3500 NE 125TH TOWNHOUSES

3023118-LU

DESIGN REVIEW RECOMMENDATION MEETING

MEETING DATE:
AUGUST 26TH, 2019

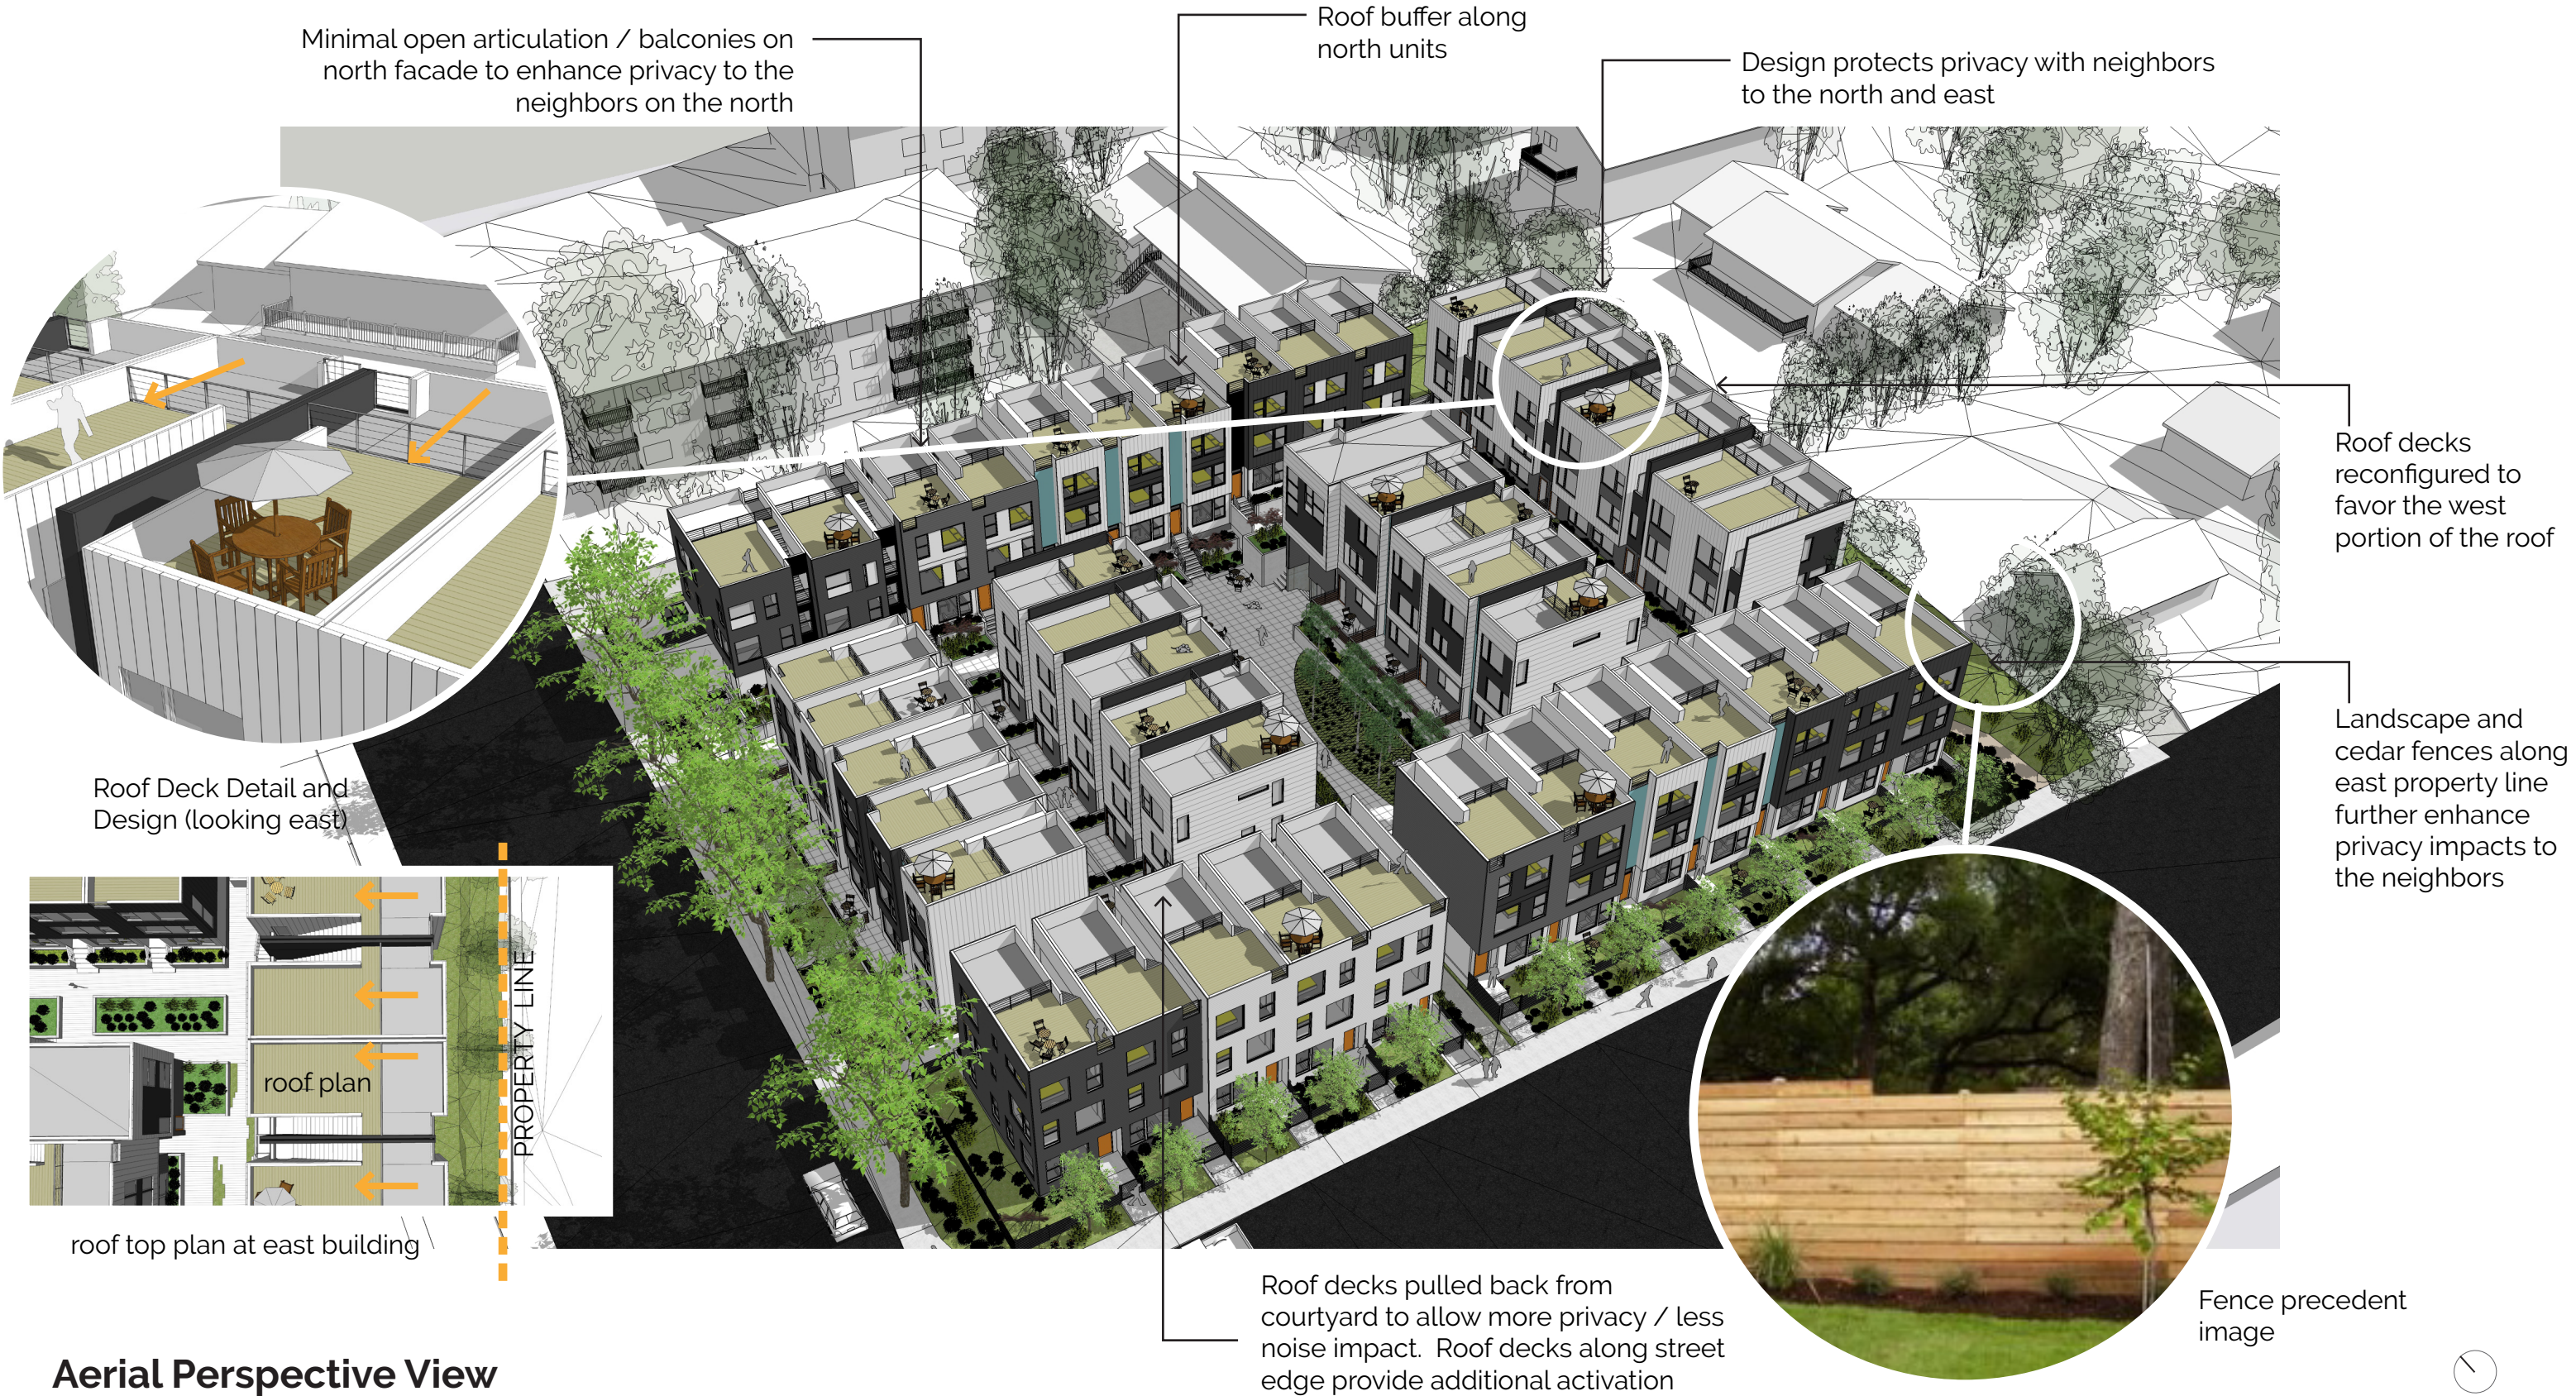
- a. No detail of individual roof decks was provided at EDG. Stair towers are evident in the axonometric drawing and should not obstruct views. Penthouse stairs should be minimized to reduce perceived height. (CS2-D)
- b. Echoing public comment regarding privacy impacts, the Board agreed that screens or planters should be added to the roof decks to keep residents from the north and east property lines. (DC3-B)

Additional detail of individual roof decks has been provided to show further thought and development that intends to mitigate privacy concerns within and surrounding the project development. All stair towers have been removed to allow for unobstructed views in all directions and to reduce perceived height. The townhouses naturally follow the topography, stepping down the slope towards 35th Ave allowing unit to unit separation.
